Central Park – Concept Plan

Proposed Public Domain Plan – Concept Plan

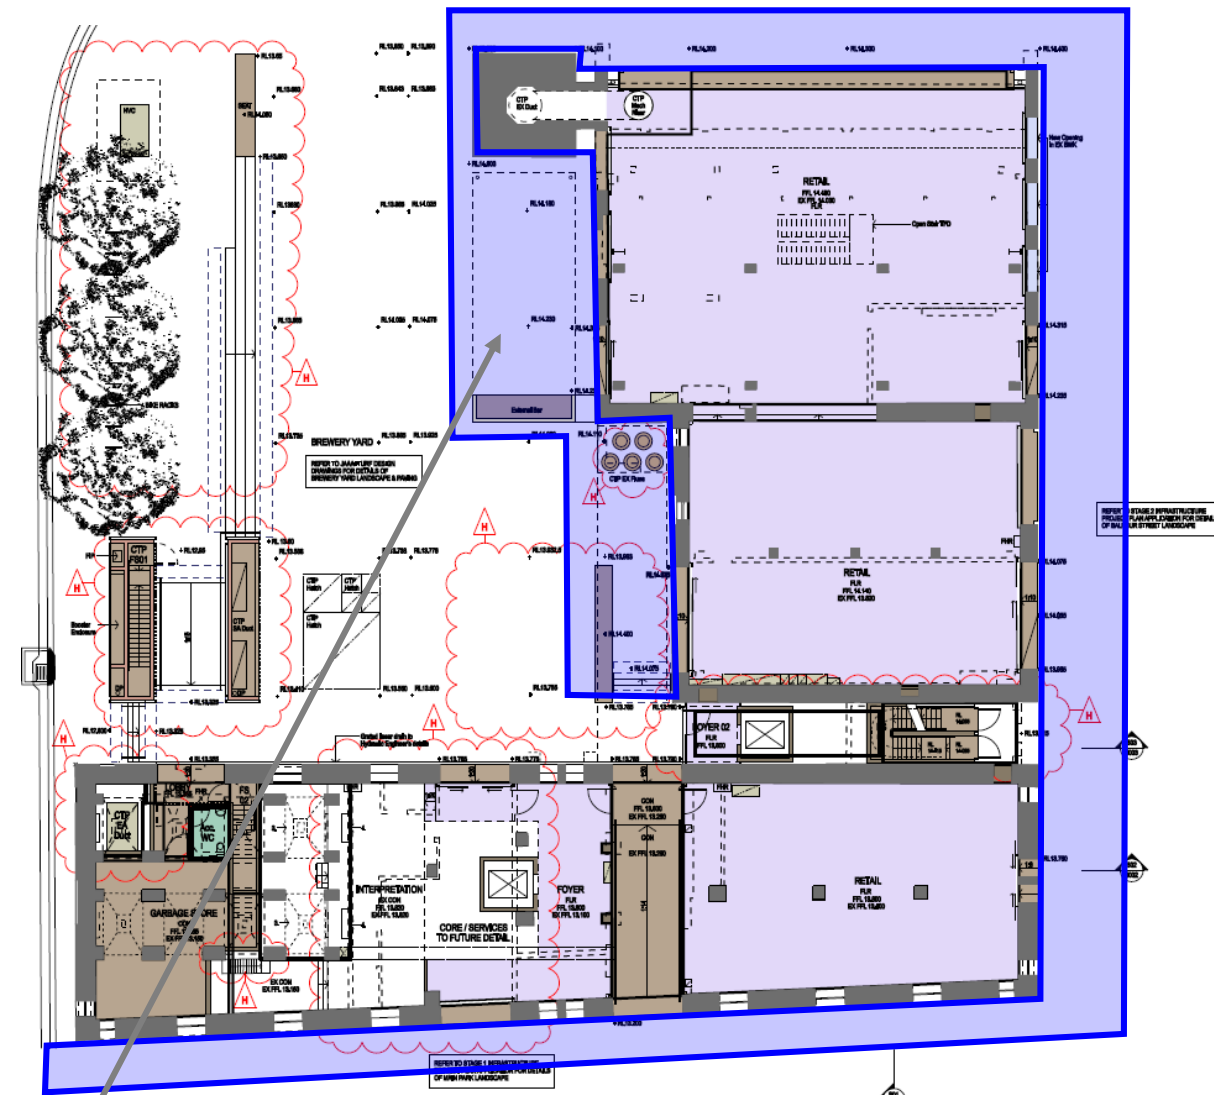
Public domain plan reflect to amend approved outdoor seating area approved in Block 4B Project Application

Central Thermal Plant Infrastructure included on the public domain plan for clarity

Publically accessible thoroughway maintained as part of the modification

Amendments to the public domain plan in these location reflect the land ownership /lot boundary of the Brewery Yard site.

Approved Plan (Ground) – MP 10_0217

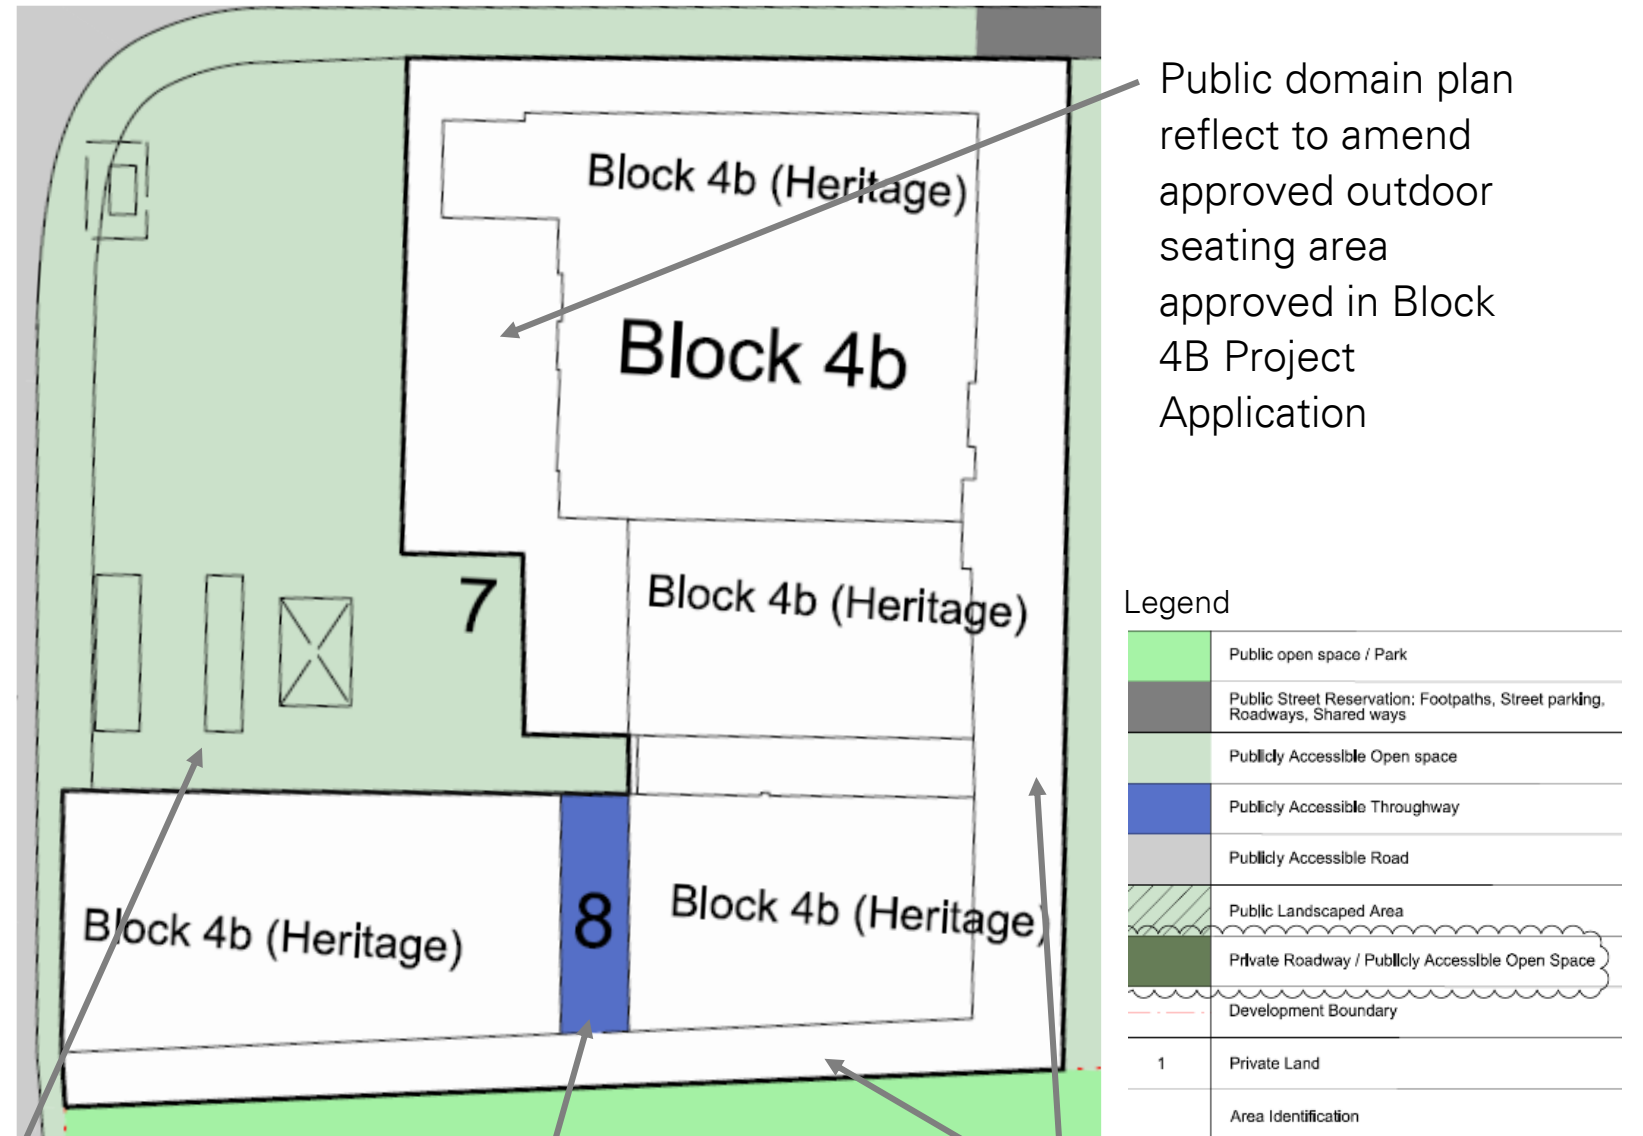
Area to be amended – shown white on the Concept Plan

Area approved with an awning over (refer architectural plans and public domain plan of the Project Application MP 10_0217). This area was approved as an outdoor seating area with awning over for use by the retail tenant.
